产品开发更改

DC No. / 开发更改编号: PDECR_0053

Customer project Name/ 客户项目名称:	57cc e-compressor	MCR No. / MCR号:	NA
Affect Product No. / 产品		Component No. / 零部件号:	
57cc e-compressor F01Z 7P0 013-04 CNHTC 57cc e-compressor F01Z 7P0 00H-01 XCMG 57cc e-compressor F01Z 7P0 012-04 Geely FD 57cc e-compressor F01Z 7P0 012 Geely SOP 57cc e-compressor F01Z 7P0 014-02 Qingling H47 45cc e-compressor F01Z 7P0 01E-01 Qingling 4.5T BEV	Offerdrawing: F01Z7D0013-01 F01Z7D000H-01 F01Z7D0012-01 F01Z7D0012 F01Z7D0014-01 F01Z7D001E-01	EOL function PMB: F01Z7S0003 F01Z7S0003-01	
Sample type / 样品类型:	☐ A ☐ B ☐ C ☒ FD	Initiator/发起人:	ZHU Qiangmin(RBCD/EIS3)

- 改善拔出时保护帽冲击力。
- PMB符合生产实际。

充氮压力试验 不同压力下保护帽弹开状态确认

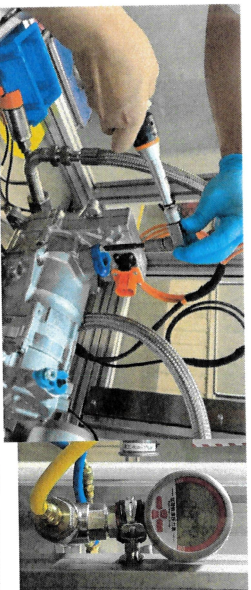
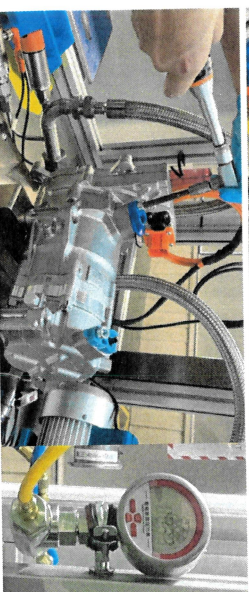
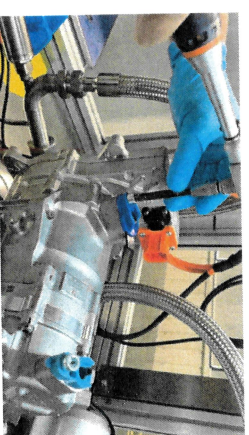
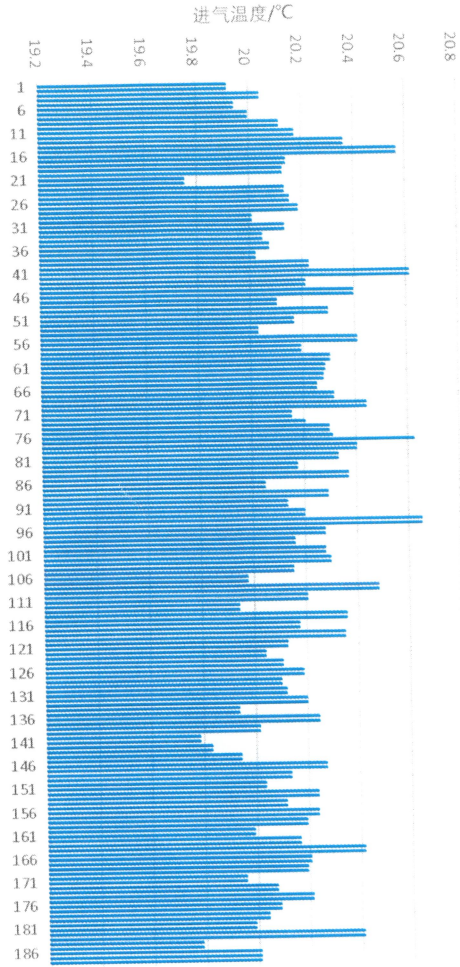
- **Background:** 产线和质量部反馈当前设定压力过高，在拆保护帽时，保护帽冲击力较大。
- 基于不同压力下的试验结果，决定降低充氮压力：0.15MPaA~0.25MPaA → 0.13MPaA~0.19MPaA。

拆保护帽时无明显压力释放声，只在拔出时有“呲”声

拆保护帽时能听到压力释放声，且冲击力很小

拆保护帽时能听到压力释放声，冲击力不大

拆保护帽时能听到压力释放声，冲击力不大

冲击力大，需挡板保护

结果: 压力在0.13MPaA~0.19MPaA之间，能够在拧松保护帽过程中感受到压缩机内正压力，并且其冲击力也不大。

eCOMP气测台架进口温度 台架进口温度传感器记录数据

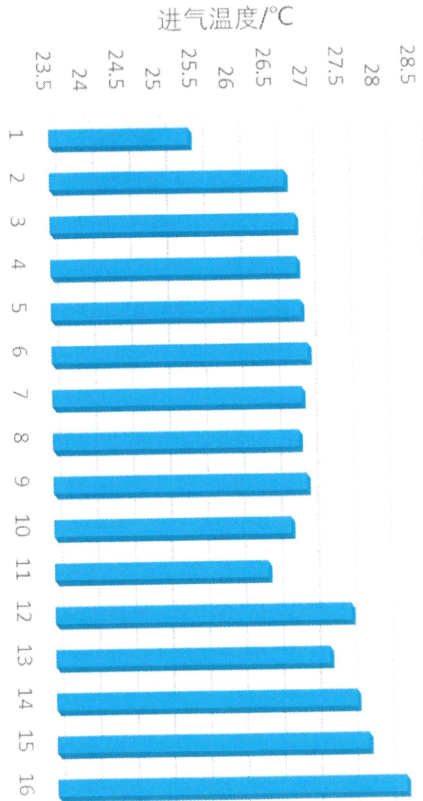
▶ 下线气测PMB中进气温度定义范围： $24.0\pm3^{\circ}\text{C}$ 。由规范定义初期为数不多的几台压缩机数据确定了初始值。测试压缩空气由FCM集中供气，空气温度受季节影响较大，当前气测台架只有气体干燥作用，无控温作用。基于过去将近一年的实际生产数据，调整进气温度设定至 $25.0\pm6^{\circ}\text{C}$ ，对压缩机下线功能检查无影响。

压缩机内部压力泄露试验

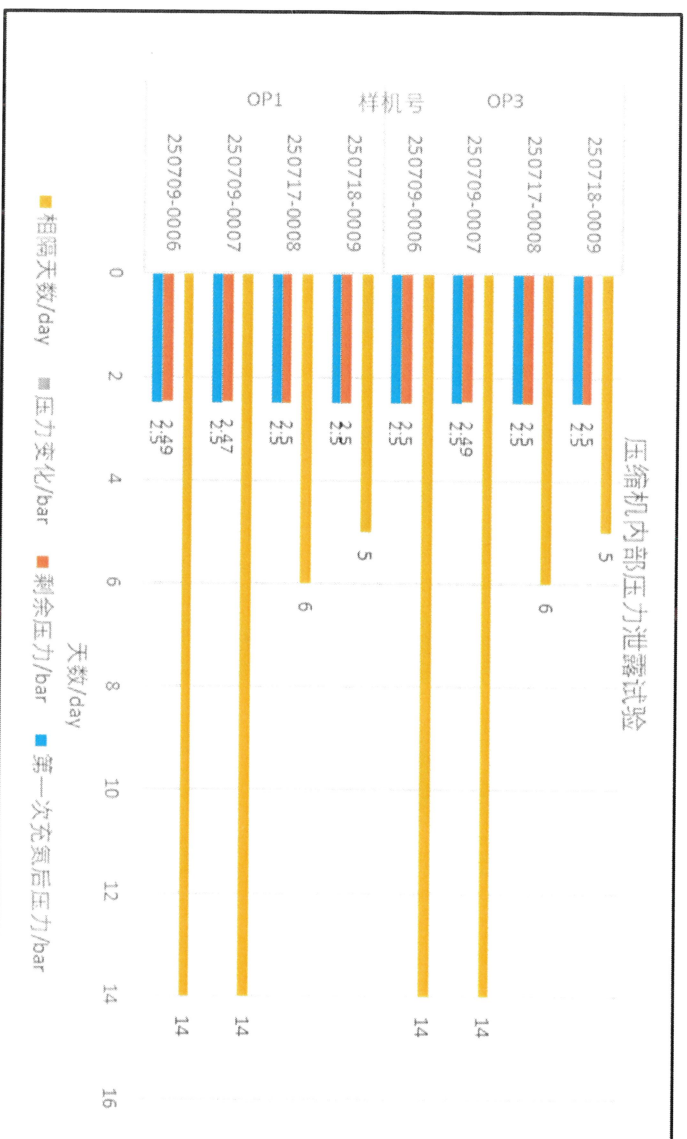
结果: 压缩机内部2.5bar压力下半个月几乎无泄露, 说明当前保护帽装配状态下内部压力保压能力良好。

理论上若压力小于2.5bar, 泄露率会更低。
